**STATE OF DELAWARE
EXECUTIVE DEPARTMENT
OFFICE OF STATE PLANNING COORDINATION**

RE: PLUS review 2013-11-03; Preserve at Cedar Pines

Thank you for meeting with State agency planners on November 27, 2013 to discuss the proposed plans for the Preserve at Cedar Pines located on Cedar Neck Road north of Ocean View. According to the information received, you are seeking site plan approval through Sussex County for 45 single family and 30 multi-family dwelling units on 29.36 acres.

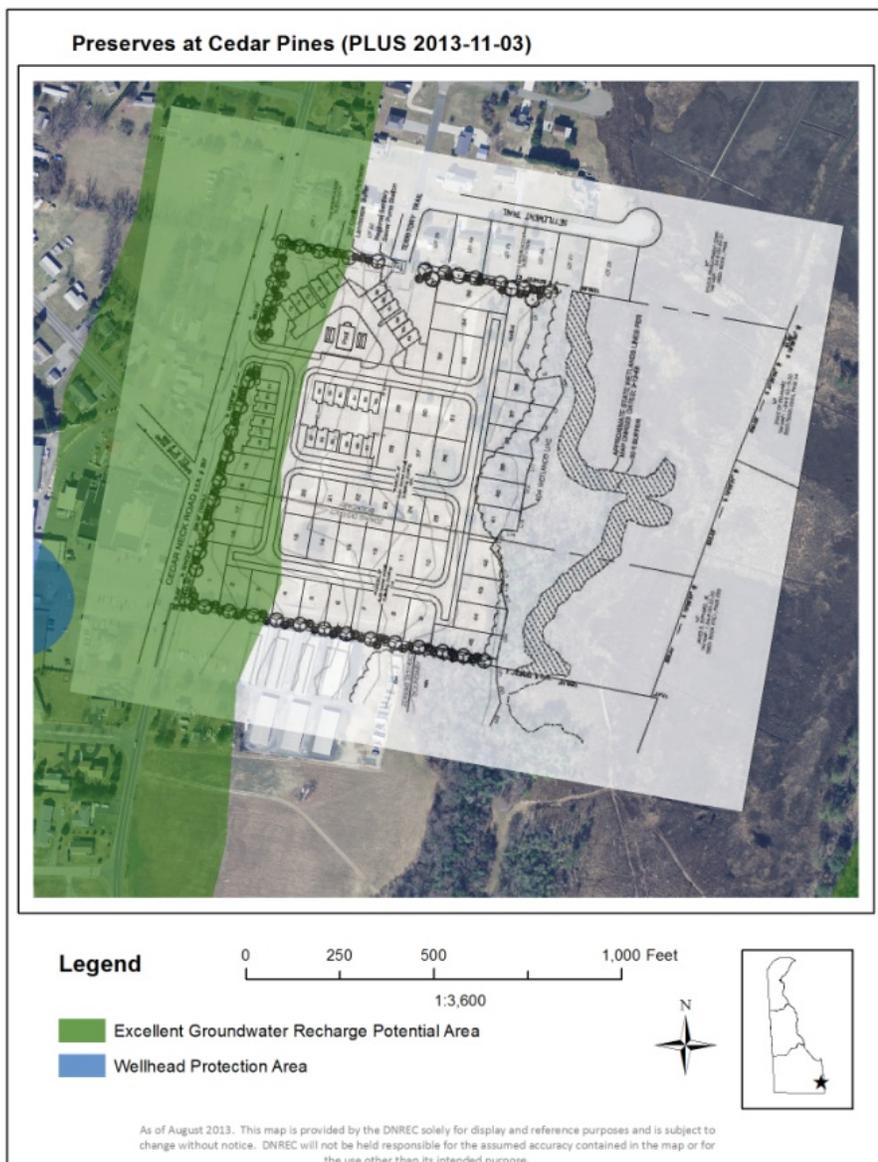
- A portion of the project falls within an area of excellent ground-water recharge potential for Sussex County (see map) and is subject to their source water protection ordinance. Excellent Ground-Water Recharge Areas are those areas mapped by the Delaware Geological Survey where the first 20 feet of subsurface soils and geologic materials are exceptionally sandy. These soils are able to transmit water very quickly from the land surface to the water table. This map category (excellent) is an indicator of how fast contaminants will move and how much water may become contaminated (Andres, 2004). Land use activities or impervious cover on areas of excellent ground-water recharge potential may adversely affect ground water in these areas.

Figure 2: SWMP mapped wetlands in the immediate vicinity of the proposed project

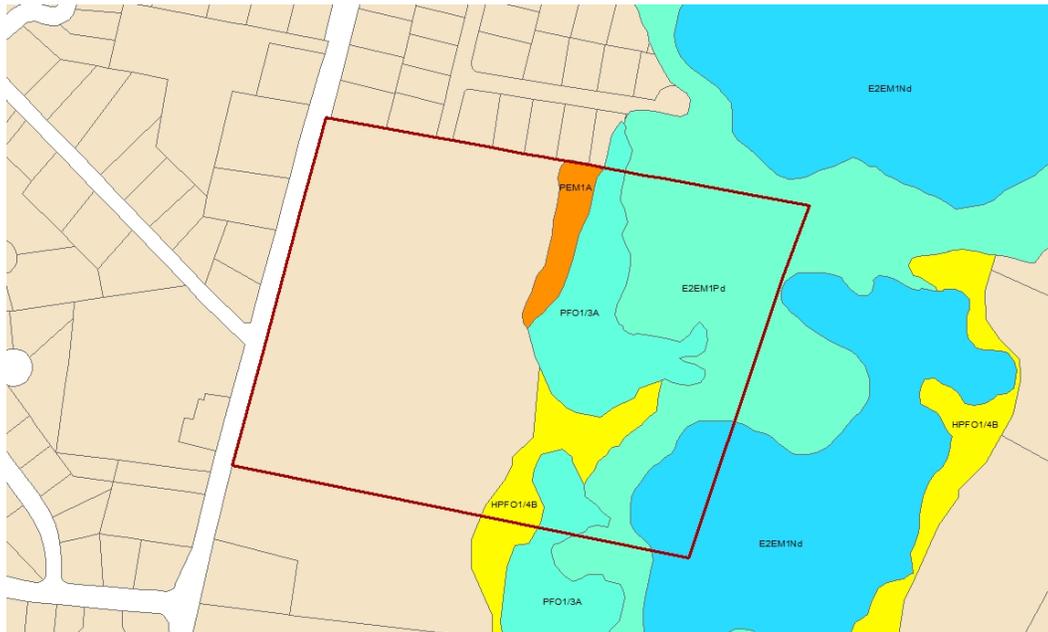
- Based on information presented in the PLUS application, a 100-foot buffer from the tidally-influenced wetlands was proposed. Since non-tidal palustrine wetlands (PEM1A, PFO1/3A, and HPFO1/4B) bound the tidal wetlands (E2EMPd &Nd), the applicant’s proposed 100-foot buffer does not sufficiently protect (i.e., buffer not wide enough) the adjoining non-tidal wetlands; it is also not sufficiently protective of water quality in adjoining waters that drain to waters in the greater Inland Bays watershed (Figure 2). Consequently, we strongly recommend the applicant establish/maintain the 100-foot buffer width from the non-tidal wetlands rather than the tidal wetlands.
